附帶規劃文件

用途：「擬議臨時公眾停車場(貨櫃車除外)及相關填土工程(為期 3 年)」

Drainage Proposal
in compliance with the Planning Approval Condition (e) of the
Planning Application No. A/YL-PH/997
for Proposed Temporary Public Vehicle Park (Excluding Container
Vehicle) for a Period of 3 Years and Filling of Land in “Village Type
Development” Zone at Lots 1043 (Part), 1046 S.A ss.1 RP (Part), 1046
S.A ss.1 S.A and HTL House Lot Blocks (Part) in D.D. 111 and
adjoining Government Land (GL), Ha Che, Pat Heung, Yuen Long,
New Territories
(HT24057B)

Responses to Comments from Government Departments on Planning Application No. A/YL-PH/997 (refer to Planning Department's message of 23 May, 2025)

PROPOSED STORMWATER DRAINAGE LAYOUT PLAN

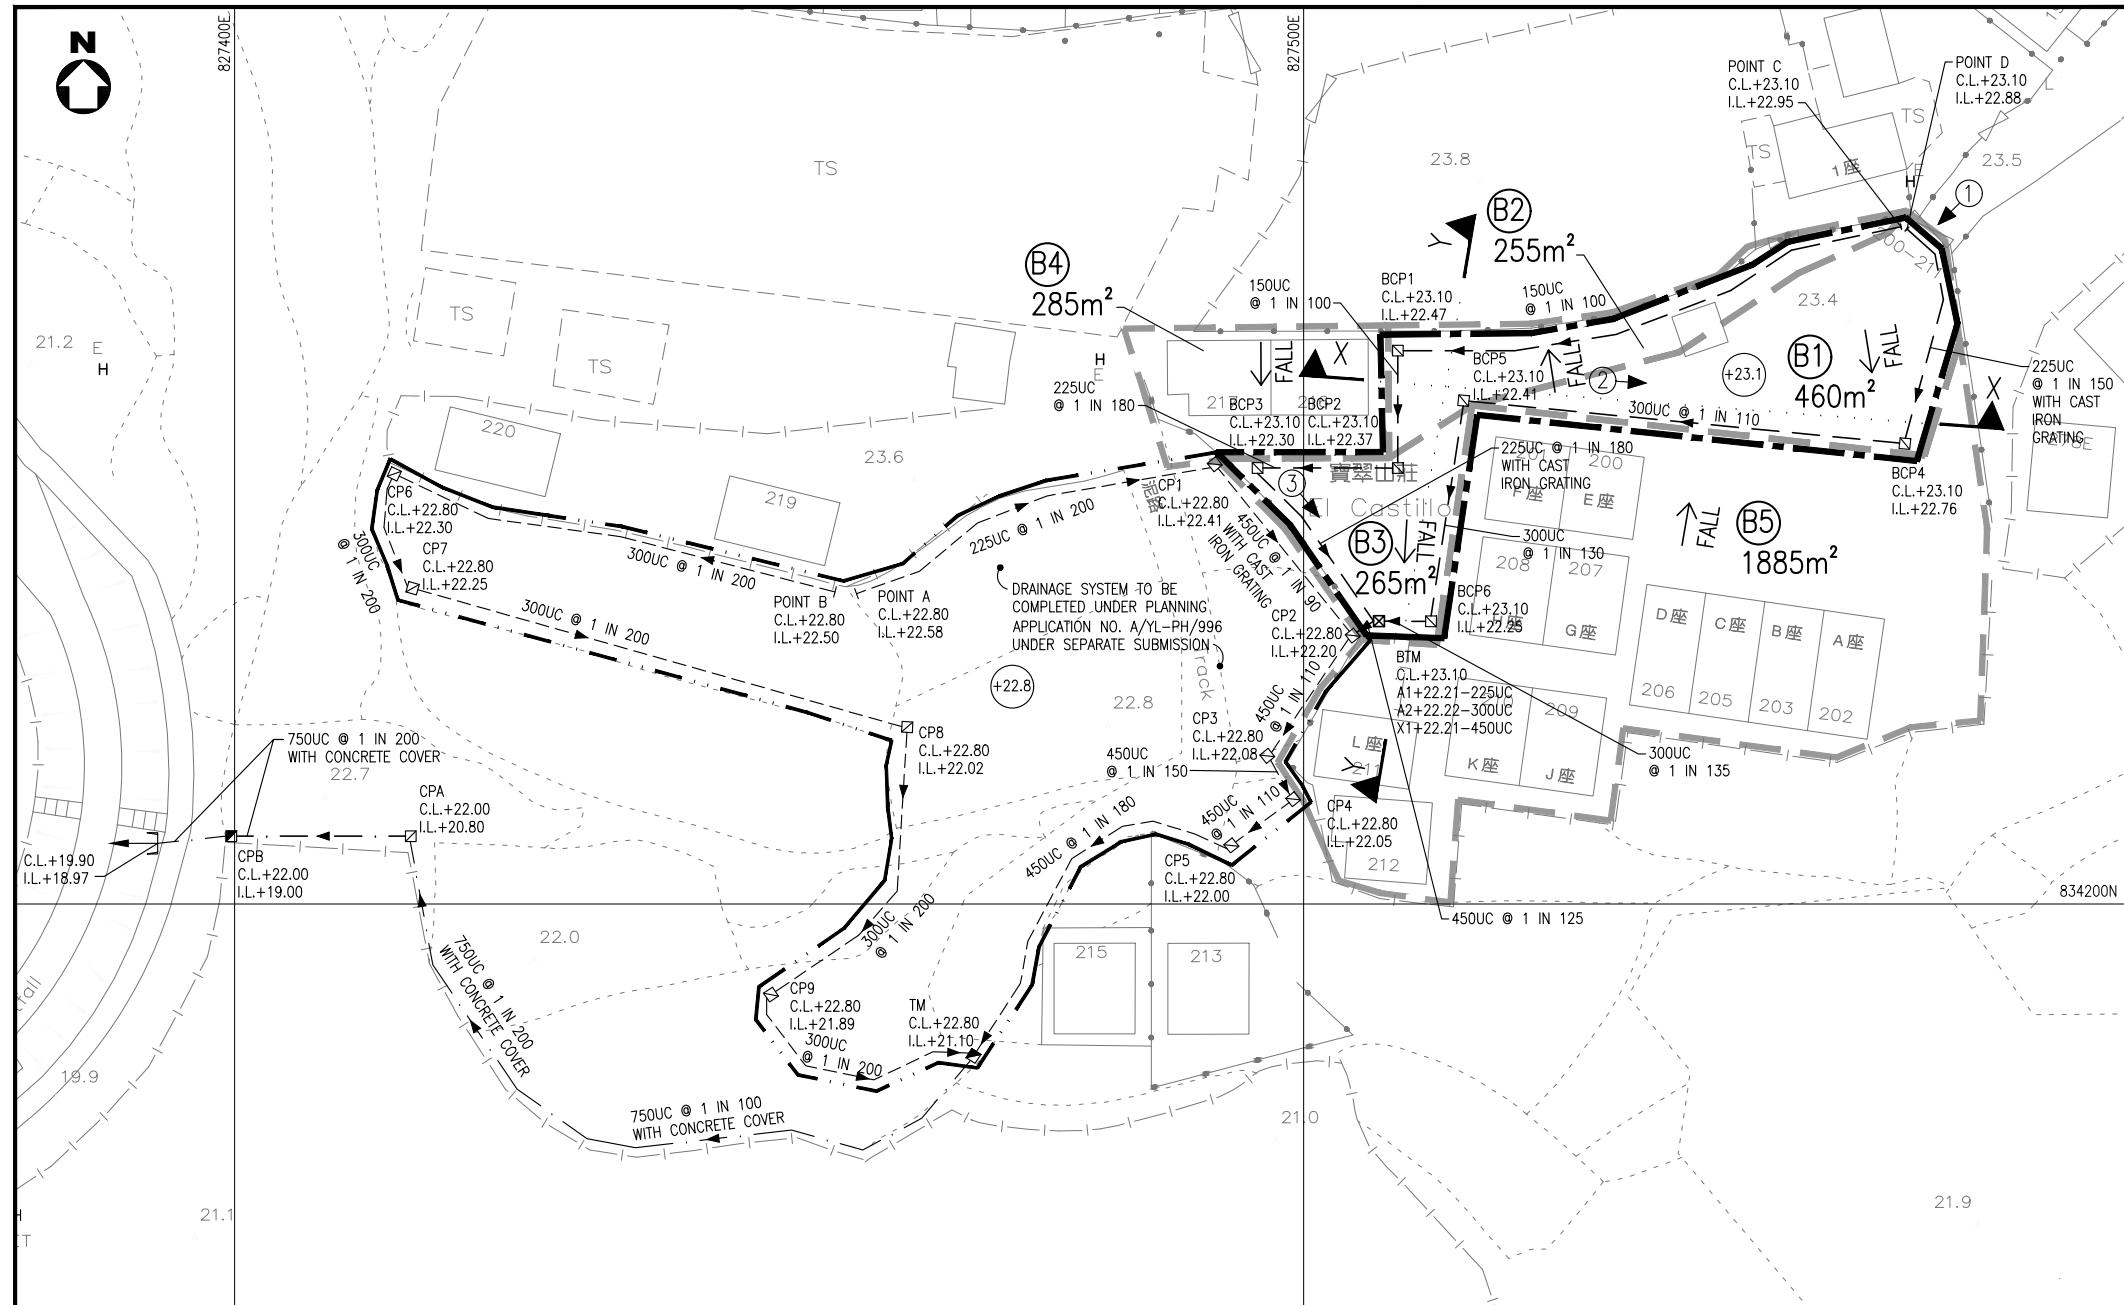
COMMENTS	RESPONSES
Drainage Service Department (DSD)	Applicant
(1) Peripheral channels will be provided within the subject site boundary to collect surface runoff on the application site and to intercept the overland flow from adjacent lands. Channels at the north eastern side of the site should be provided.	Peripheral channel is added at the north eastern side of the subject site.

DETAILS OF OUTFALL
(SUBMITTED & AGREED UNDER
PLANNING APPLICATION NO. A/YL-PH/996)

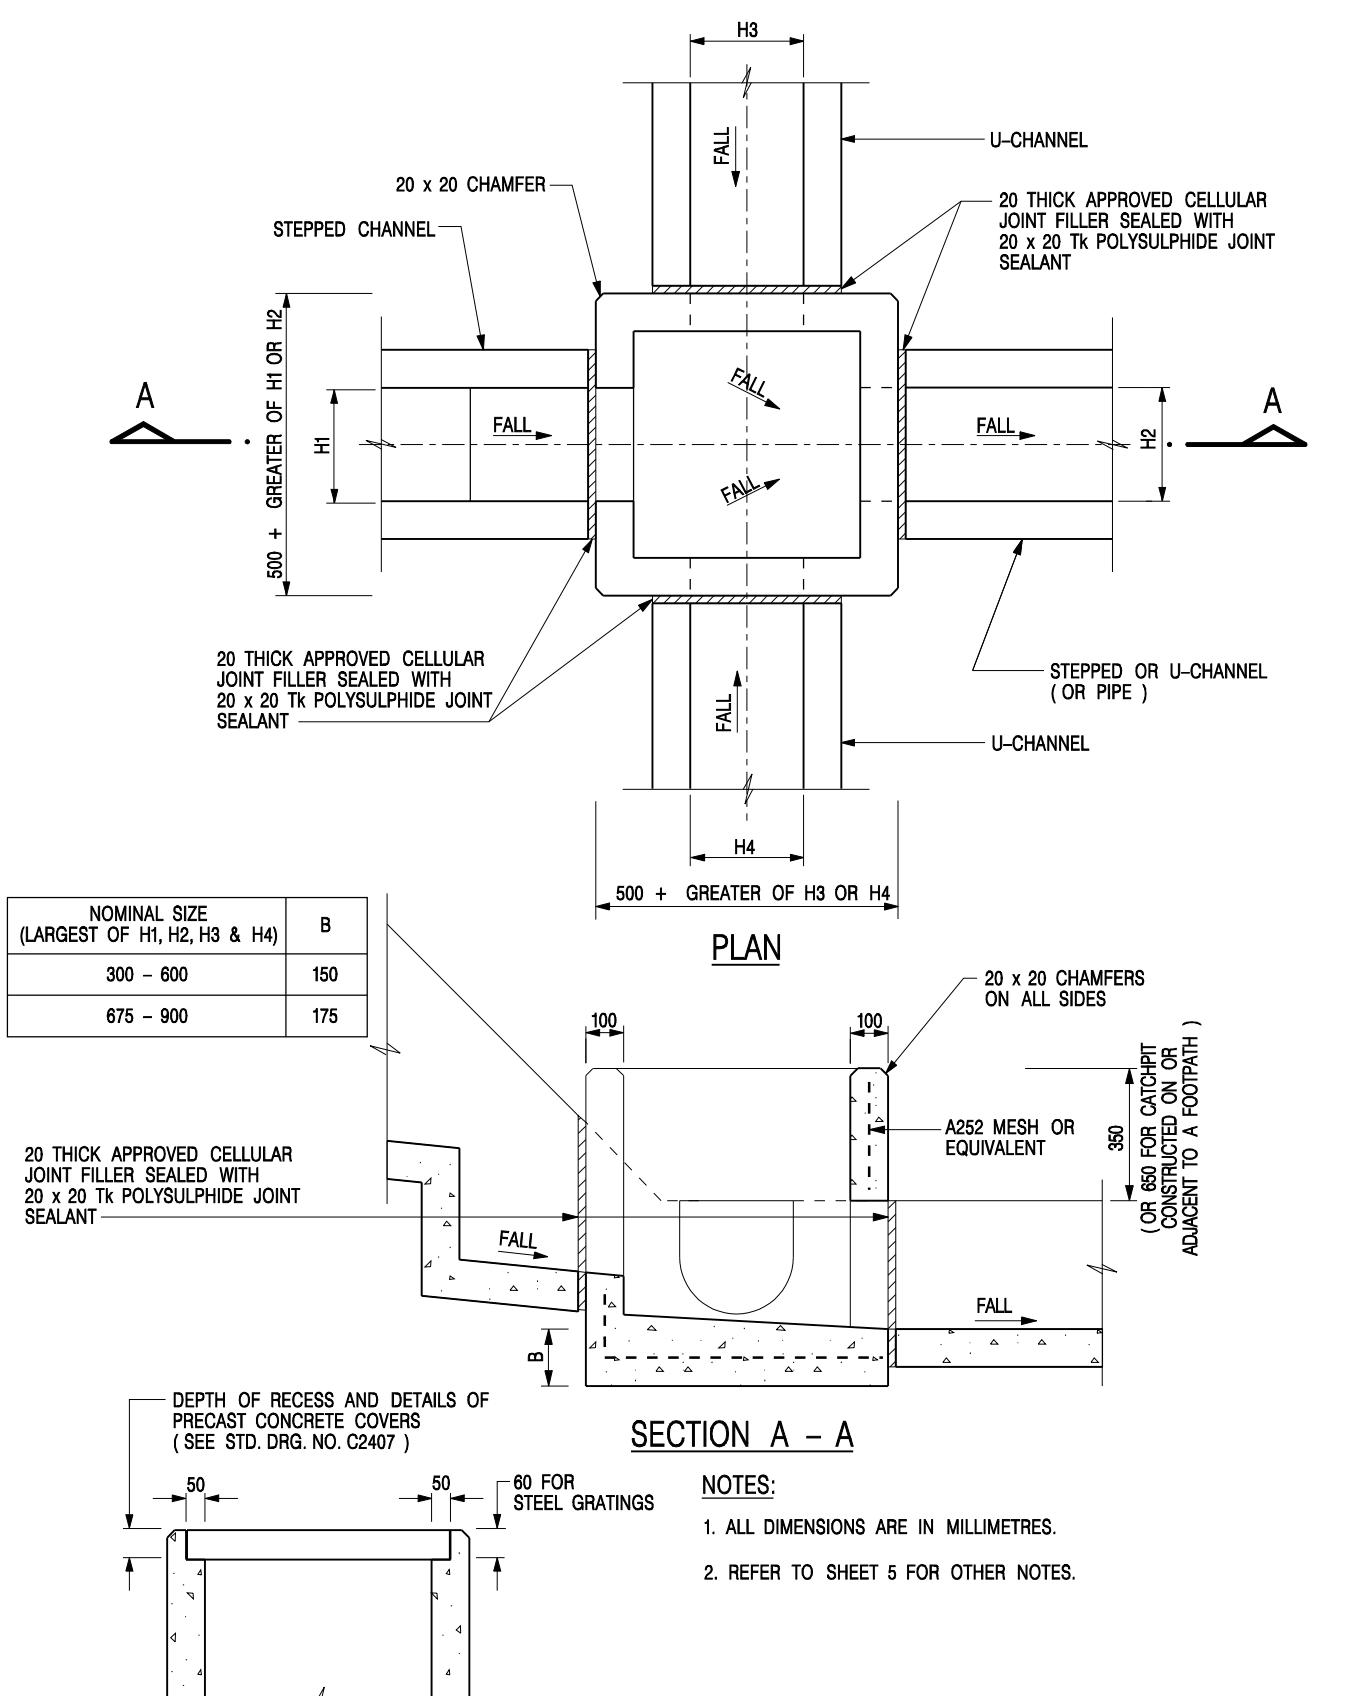
(7) The connection details at discharge point (drain pipe under planning application No. A/YL-PH/996) and indicate all C.L., I.L and catchpit bottom level should be shown in the drawing.	Details of outfall submitted and agreed under Planning Application No. A/YL-PH/996 is enclosed as Figure 4 in this amended report.

**COVER SLAB AND CAST IRON
GRATING FOR CHANNELS**

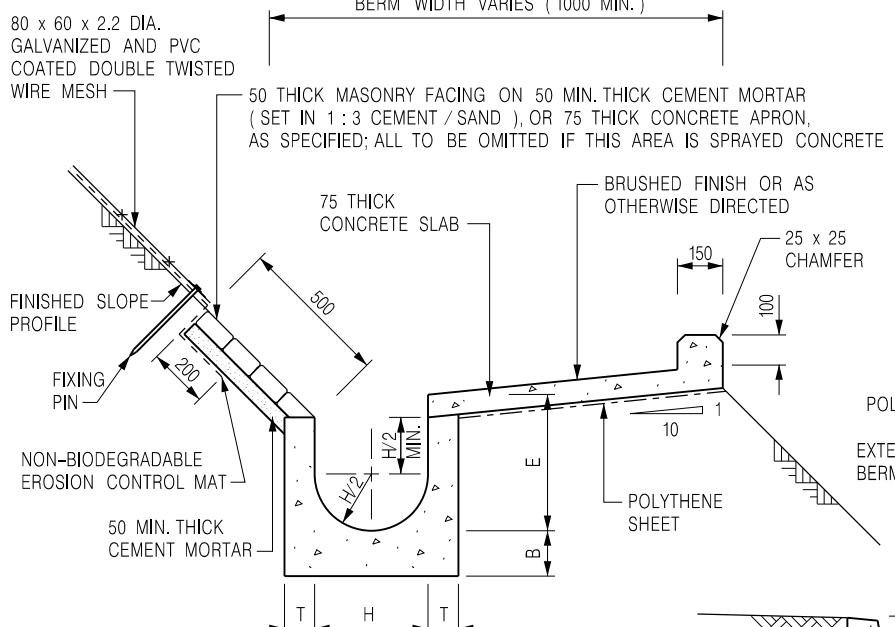
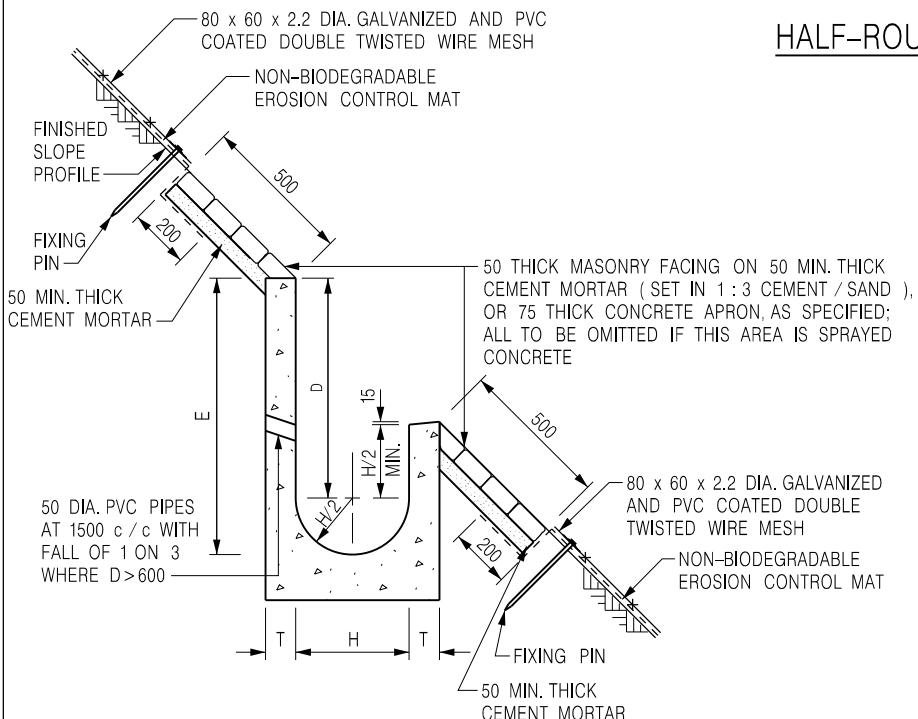
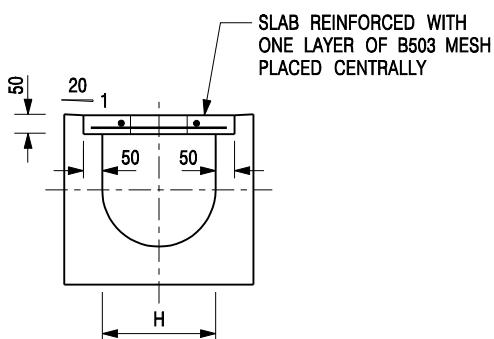
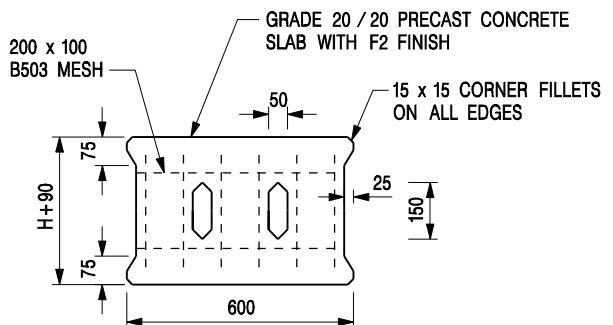
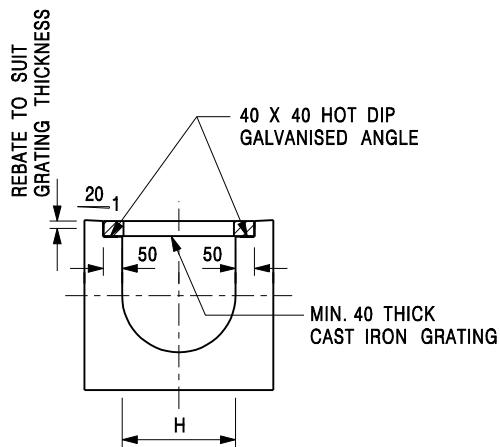
(4) There is no C2409I in the Civil Engineering and Development Department's standard list. The applicant is advised to check and clarify.	The updated Civil Engineering and Development Department's standard drawing no. C2409J is used.

(5) The standard drawings of cover slab/cast iron grating etc., for the proposed channels should be included in the submission. The Drainage Services Department's approval shall be sought for decking over channels.	Civil Engineering and Development Department's standard drawing of 'cover slab and cast iron grating for channels' (no. C2409J) is incorporated into this amended report.
